## ADDENDUM NO. 1 TO CONTRACT DOCUMENTS

Project: MacDonald Downs Pump Station H&S Project No. 30906-006

Owner: City of Havelock

Date: 10/10/2017

Detail 1511502 Yard Hydrant

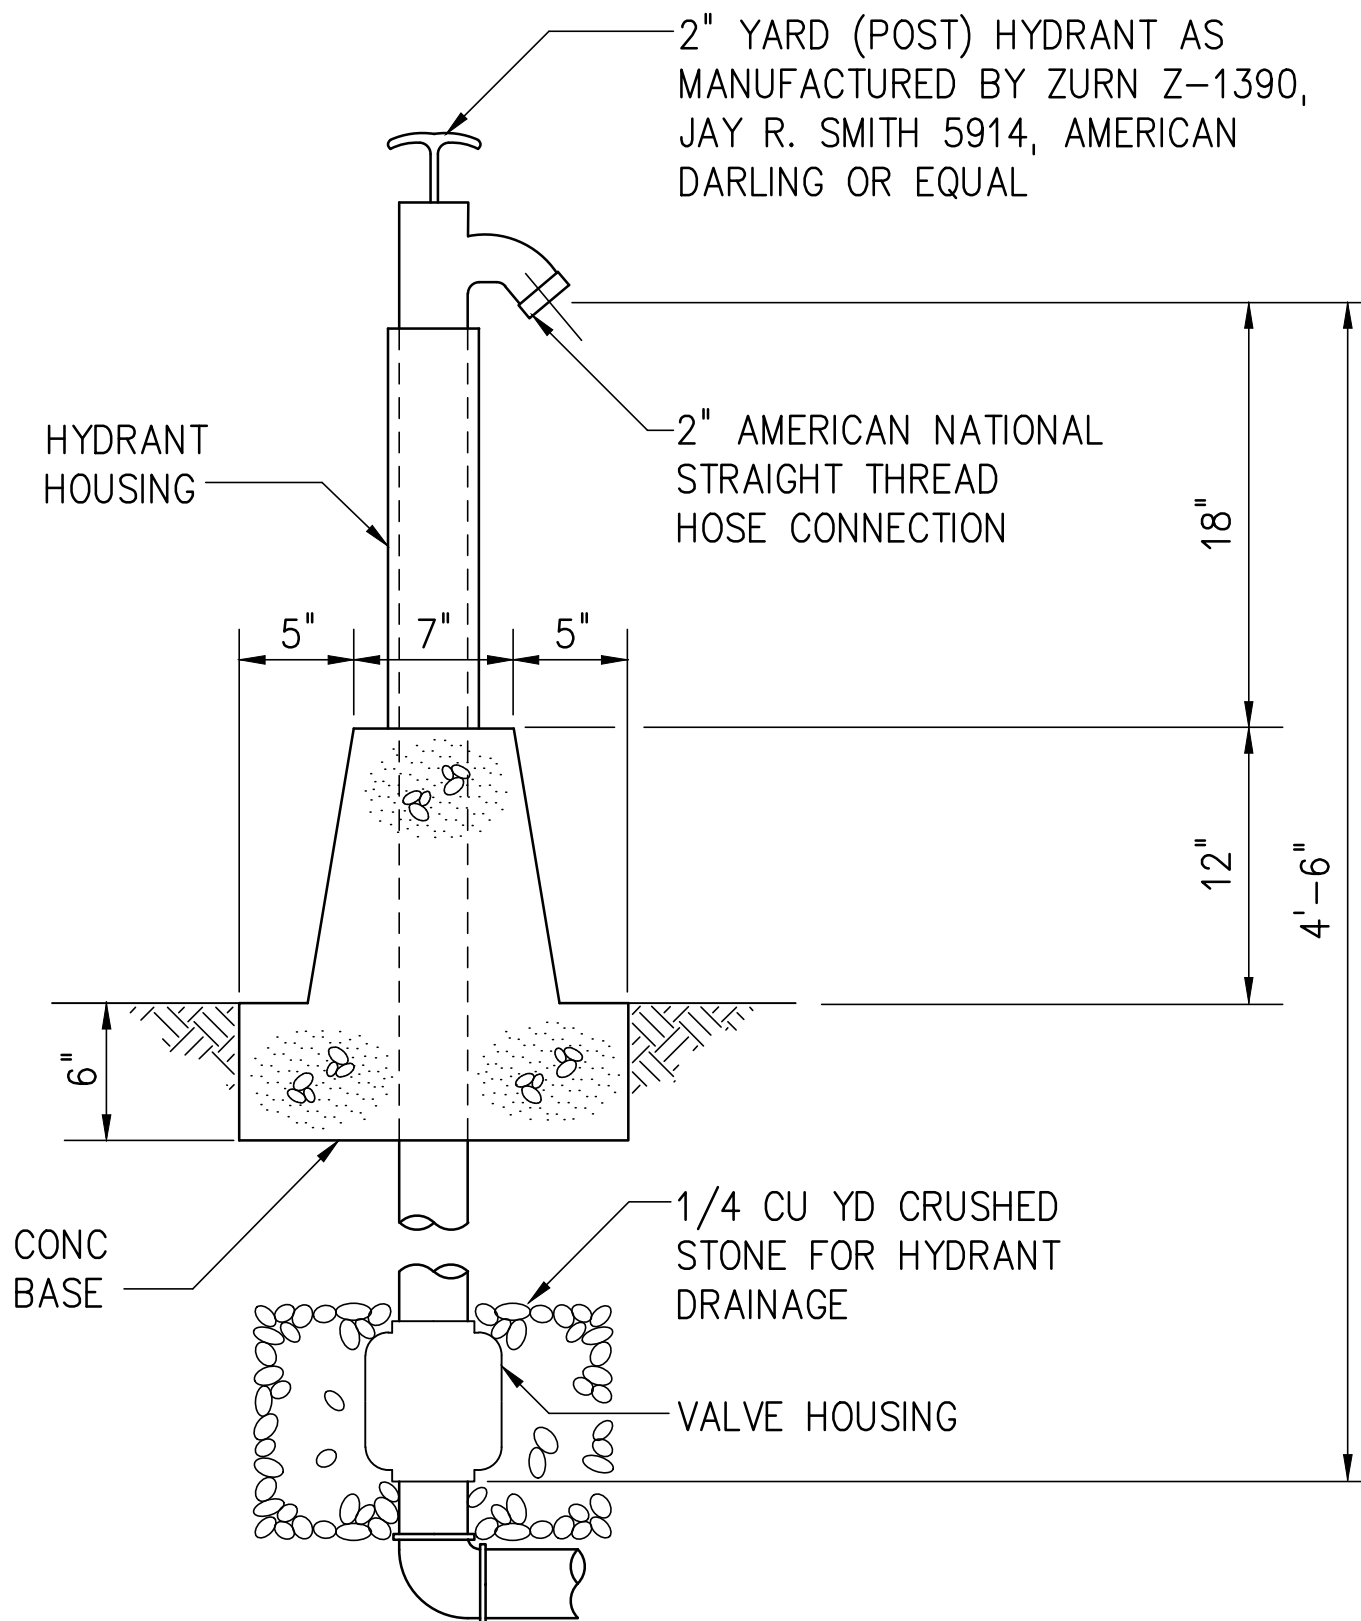
| <u>Item 1.</u> Drawing C-1  | Add the following NOTE:<br>"3. Install a 2 inch water service connection, including a meter and backflow preventer, from the existing 10 inch PVC water line in the US70 right of way to the new pump station site. Meter and backflow preventer shall be to City of Havelock standards. Install approximately 700 lf of 2 inch Schedule 40 PVC water line and fittings in the existing force main easement along the property line. PVC pipe shall conform to ASTM D 1785 and fittings shall conform to ASTM D2466. Terminate the water service with a yard hydrant per detail 1511502. Owner shall designate location of the yard hydrant inside the new pump station fence." |
| <u>Item 8.</u> Drawing D-03   | Add attached Yard Hydrant Detail 1511502  |
